CRBRP SPECIAL STRESS AND CRITERIA CONSIDERATIONS

CRBRP ENGINEERING STUDY REPORT

ES-LPD-82-009

This report provides responses to specific NRC questions on CRBRP stress and criteria considerations.

FIGURE 3.0-14. Creep Strains Increase Proportionately in Elbows (Analysis III)

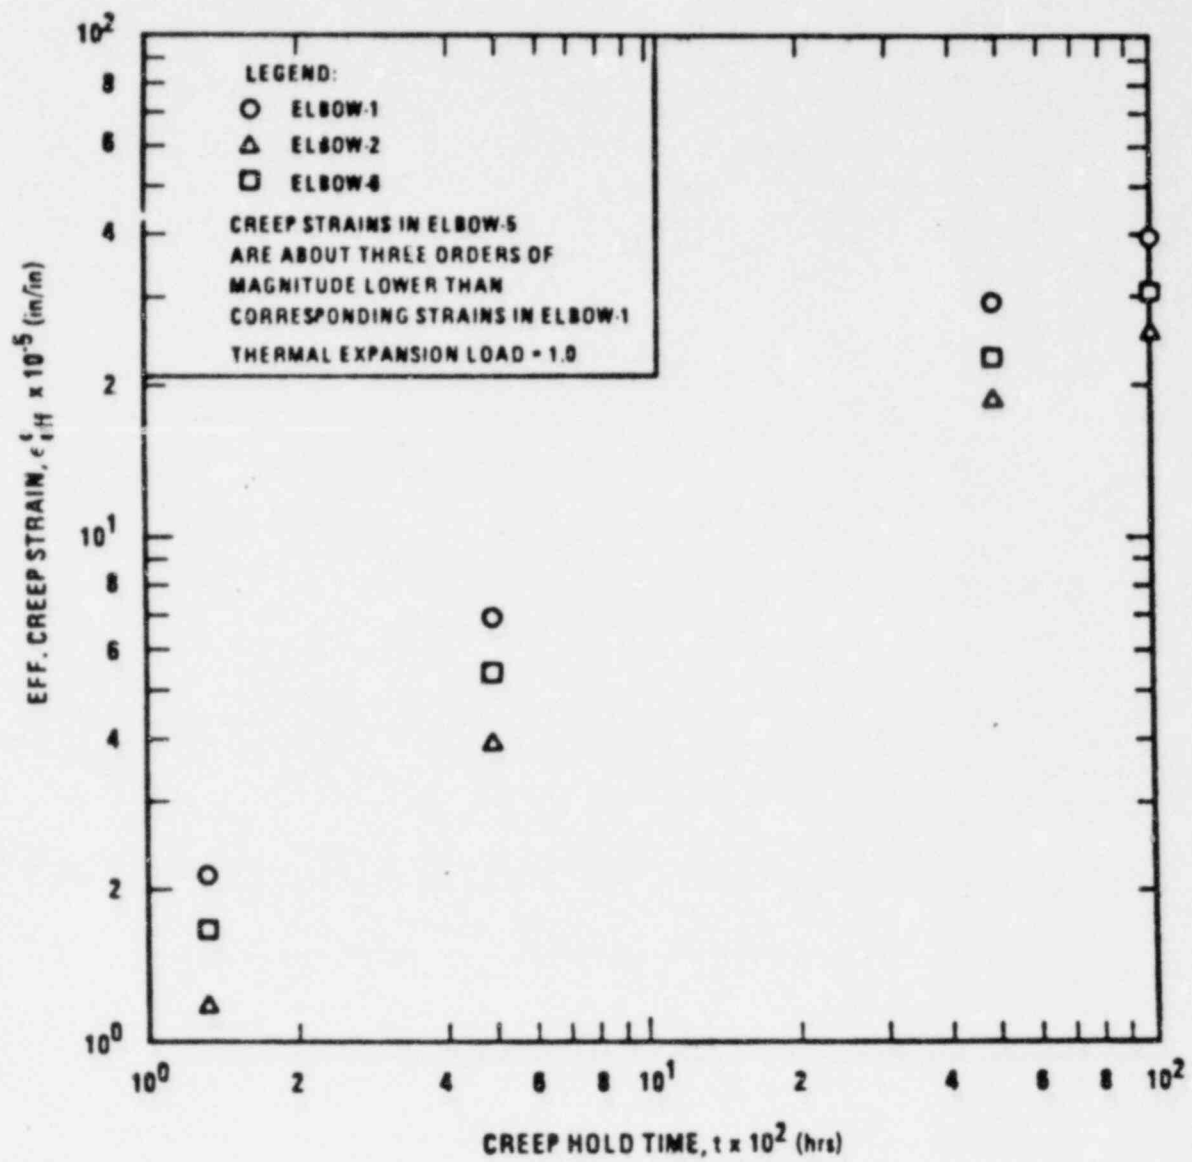
Figure 14 is another plot, which shows the creep strain behavior predicted by Analysis III. It plots the creep hold time versus the effective creep

rain. In one of the elbows which is not plotted here, the strains are so small that it does not show up on this log-log scale.

FIGURE 4.0-4

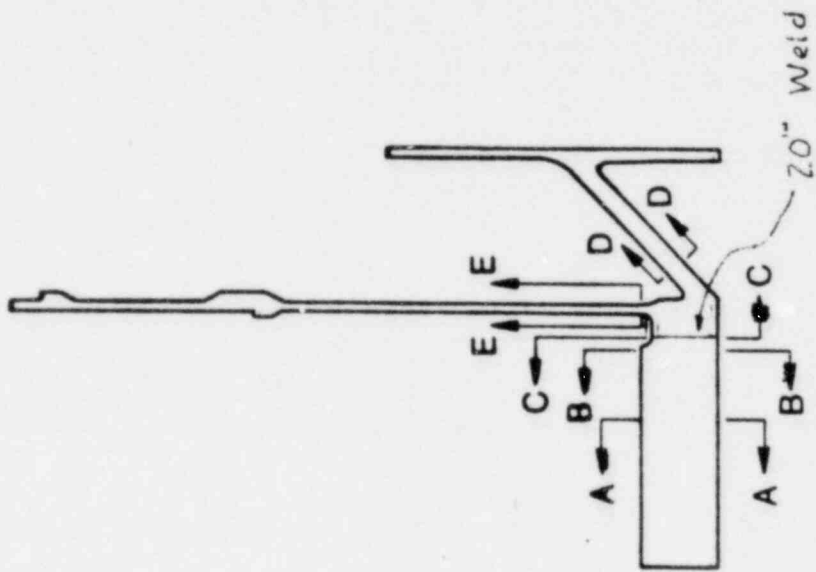
The other element where we took an exception to Code Case 1592-7 was in the weld from the core support structure forging to the core support plate, a very thick weld (Figure 4). It was about a 20-inch depth weld between the plate and the ring forging. In that particular case, radiographic inspection, which would be in accordance with the rules of Class 1 components, was not deemed feasible, nor was it deemed to give us a reasonable evaluation of the adequacy of the weld.
